UKWIN'S D9 RESPONSE TO REP8-023

**REP8-023: 9.33 - APPLICANT'S COMMENTS
ON SUBMISSIONS RECEIVED AT DEADLINE 7**

North Lincolnshire Green Energy Park

EN010116

Chart of fall in waste per capita in 2027 and 2042 relative to a 2019/2020 base year

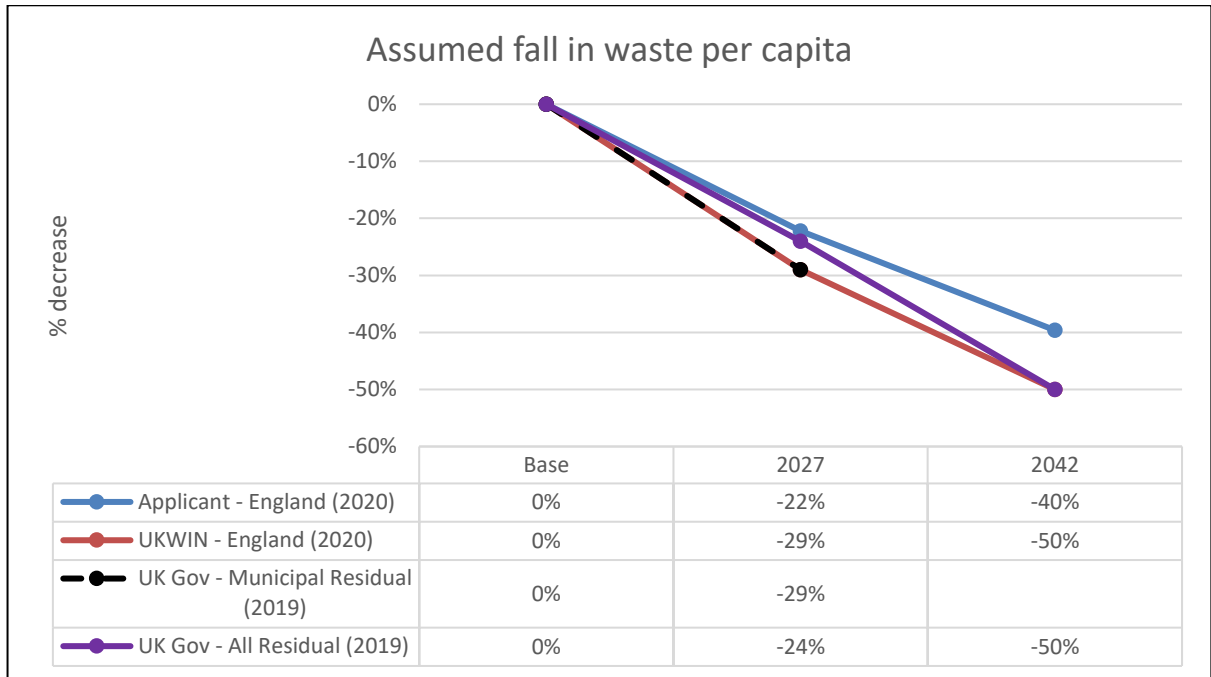
20. UKWIN provided detailed evidence on this point at Deadline 8, but to help explain the point UKWIN is making we directly compare (overleaf) the Applicant’s assumptions regarding the fall in waste per capita from 2020 to 2027 and from 2020 to 2042 against the Government’s anticipated trajectories for falls in residual waste and municipal residual waste.
21. Such a comparison clearly shows how the Applicant’s approach is not consistent with UK Government waste targets, whereas UKWIN’s approach is consistent with feedstock falling in line with UK Government targets.

26. However, rather than assuming falls in line with any of the Government's targets, the Applicant instead assumes that their feedstock would fall by only around 22% per capita by 2027 and thereafter by only around 40% per capita by 2042 (compared to a 2020 base year).

27. The waste stream that the Applicant is relying on for feedstock would therefore be assumed by the Applicant to have significantly lower falls (i.e. smaller reductions) per capita than those indicated by the EIP targets.

28. Put another way, the Applicant's assumed trajectory is inconsistent with achieving the Government's targets.
29. To calculate the 22% and 40% per capita figures associated with the Applicant's numbers in their ExQ2 response (REP6-032) we first calculated the Applicant's assumed level of waste as fuel available per capita for 2020:
